Subject: **SERIAL ERROR AT ACTIVE OUT**

Model: **BKM-2085-14, BKM-2085-20**
DMIF-1000

Serial No: **BKM-2085-14 (UP TO 2,000,810)**
BKM-2085-20 (UP TO 2,000,755)
DMIF-1000 (UP TO 2,001,960)

Figure 1

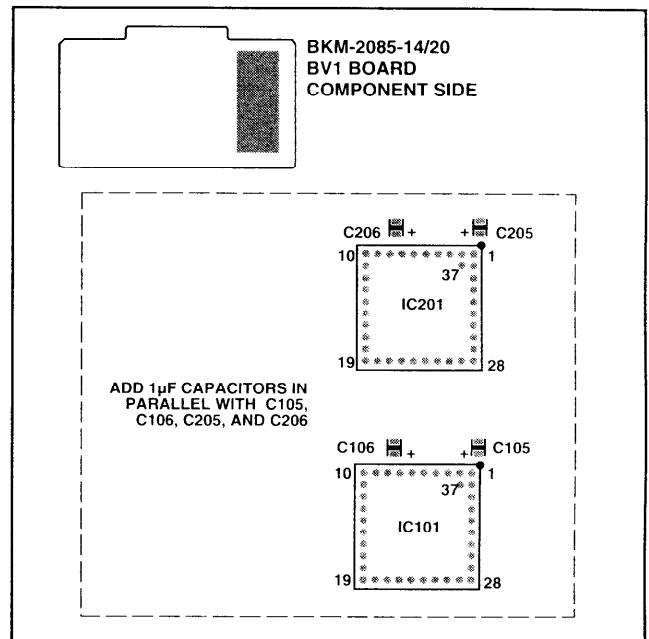
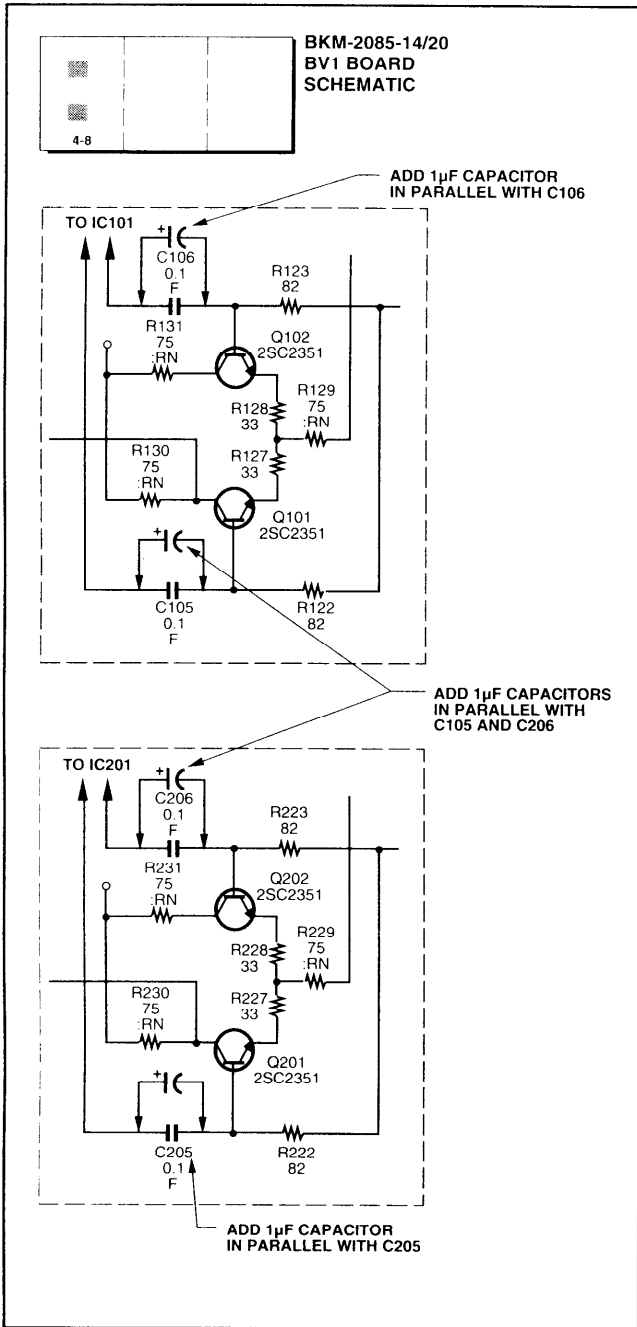
BKM-2085-14/-20
BV1 Board, Component Side
 (See Figure 1 and 3.)

Solder four 1 μ F electrolytic capacitors in parallel with C105, C106, C205, and C206. (Note polarity.)

Figure 2

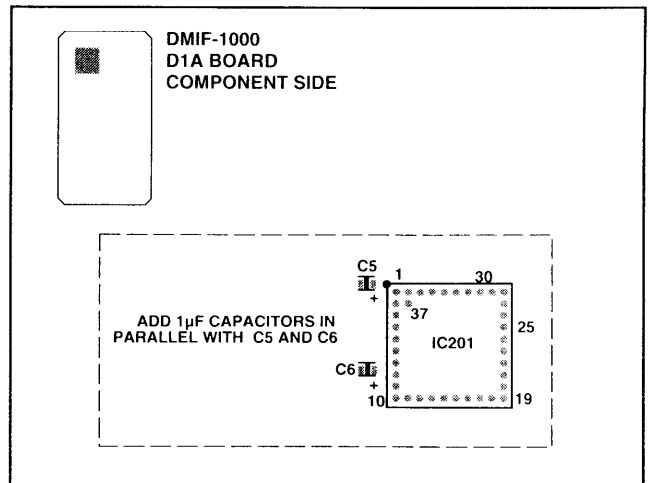
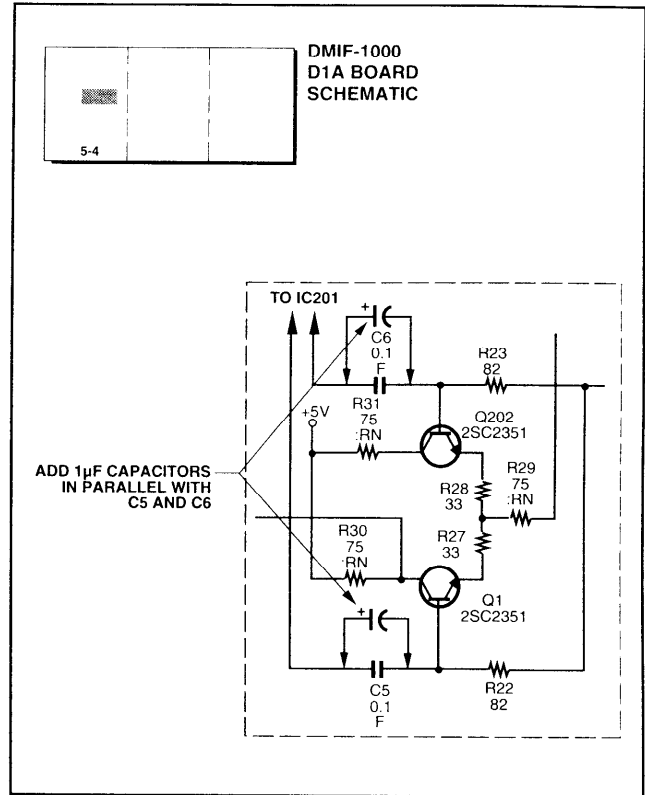
DMIF-1000
D1A Board, Component Side
 (See Figure 2 and 4.)

Solder two 1 μ F electrolytic capacitors in parallel with C5 and C6. (Note polarity.)
